Title - Sujet CBSA, CCTV AT JEAN-LESAGE AIRPORT CBSA, CLOSE CIRCUIT TELEVISION (CCTV) SYSTEM AT JEAN LESAGE INTERNAI	
Solicitation No. - N° de l'invitation 47419-189043/B	Amendment No. - N° modif. 001
Client Reference No. - N° de référence du client 1000339042	Date 2020-11-23
GETS Reference No. - N° de référence de SEAG PW-\$\$HN-467-79230	
File No. - N° de dossier hn467.47419-189043	CCC No./N° CCC - FMS No./N° VME
Solicitation Closes - L'invitation prend fin at - à 02:00 PM Eastern Standard Time EST on - le 2020-12-10 Heure Normale de l'Est HNE	
F.O.B. - F.A.B.	
Plant-Usine: <input type="checkbox"/> Destination: <input type="checkbox"/> Other-Autre: <input type="checkbox"/>	
Address Enquiries to: - Adresser toutes questions à: Dubé, Robert	Buyer Id - Id de l'acheteur hn467
Telephone No. - N° de téléphone (613) 296-1526 ()	FAX No. - N° de FAX (613) 943-7620
Destination - of Goods, Services, and Construction: Destination - des biens, services et construction:

AMENDMENT #001

APPENDIX 1 TO AMENDMENT 001

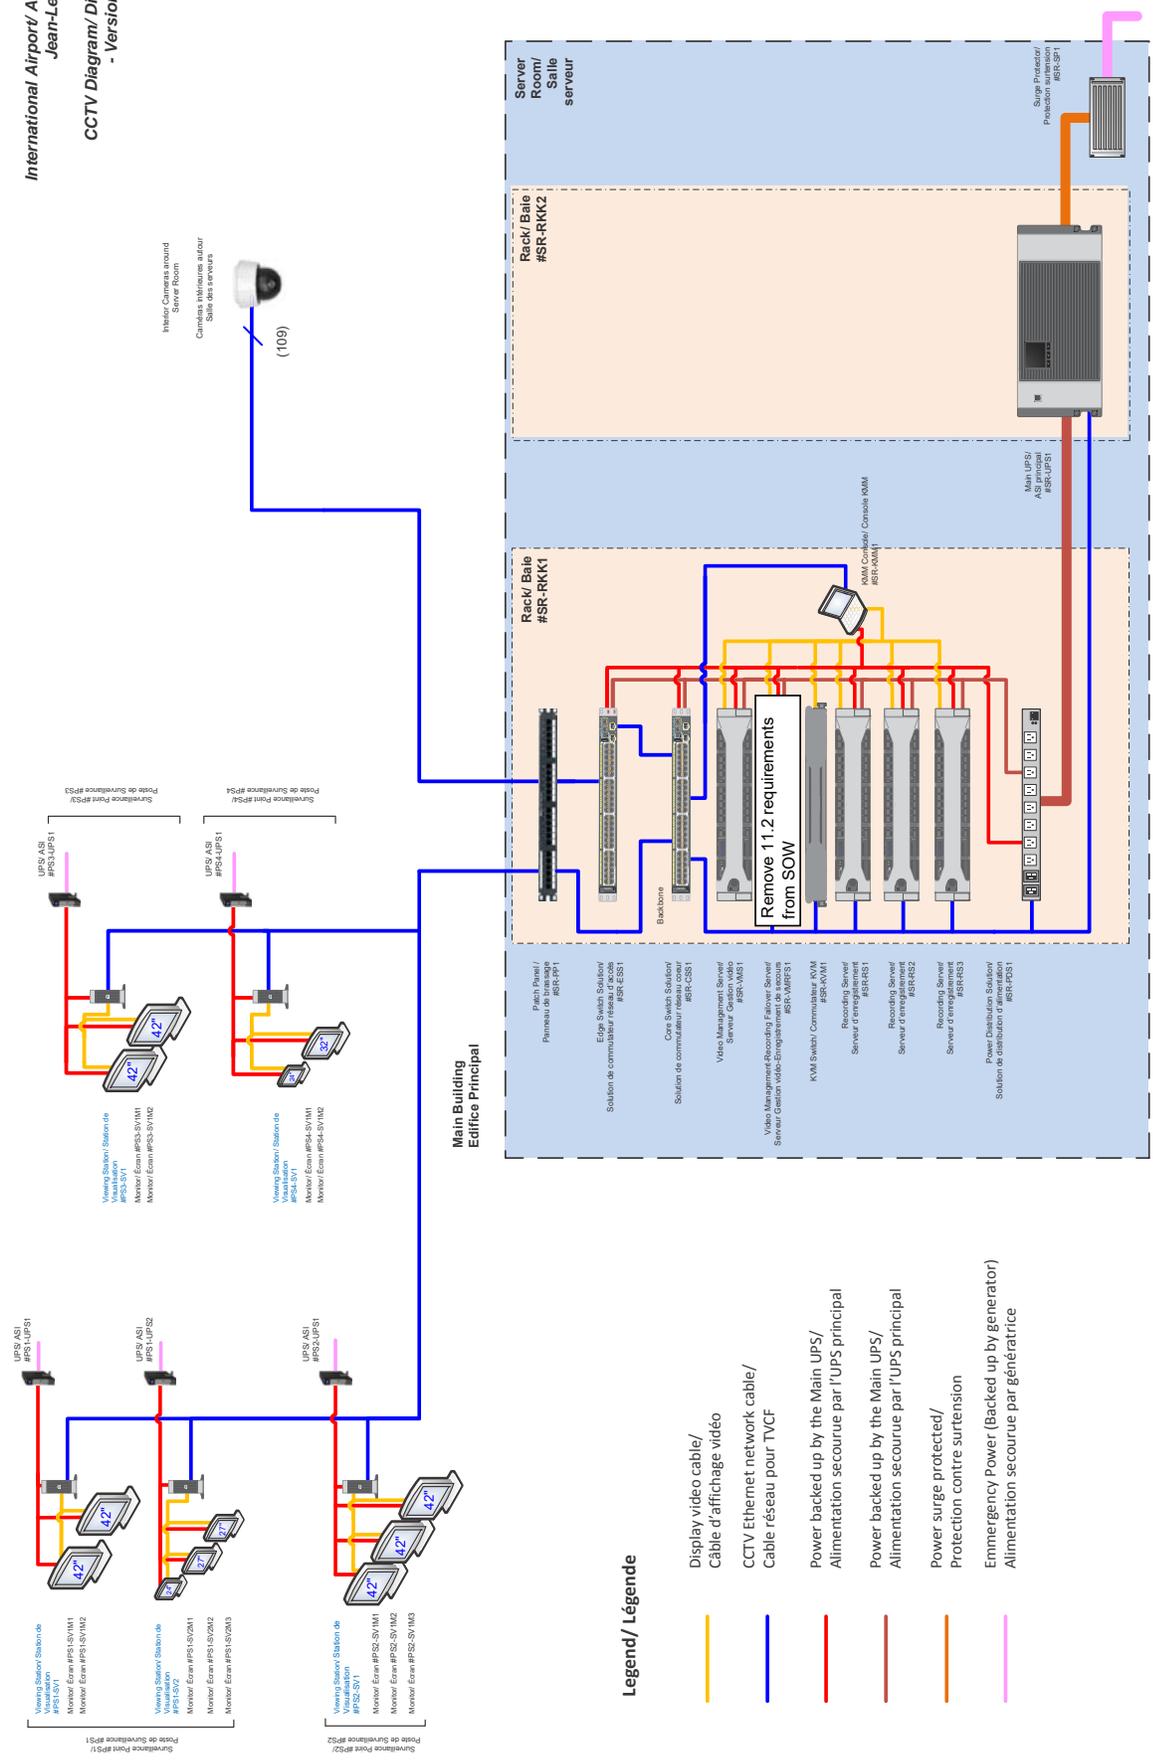
2. All cabling has been tested, labeled and documented. This information will be provided to the Contractor upon contract award.
3. As requested, please find in the attached Appendix 1 of Amendment 001 an improved resolution of Figure 1 – CCTV System Architecture Diagram of Section 3 of the Statement of Work (SOW).

1-In section 3. CCTV System Architecture Specifications. Under "The CCTV solution includes" (p.7)

DELETE: third item "One (1) x Video Management Failover / Video Recording Failover Server" (see APPENDIX 1 TO AMENDMENT 001, figure 1 below).
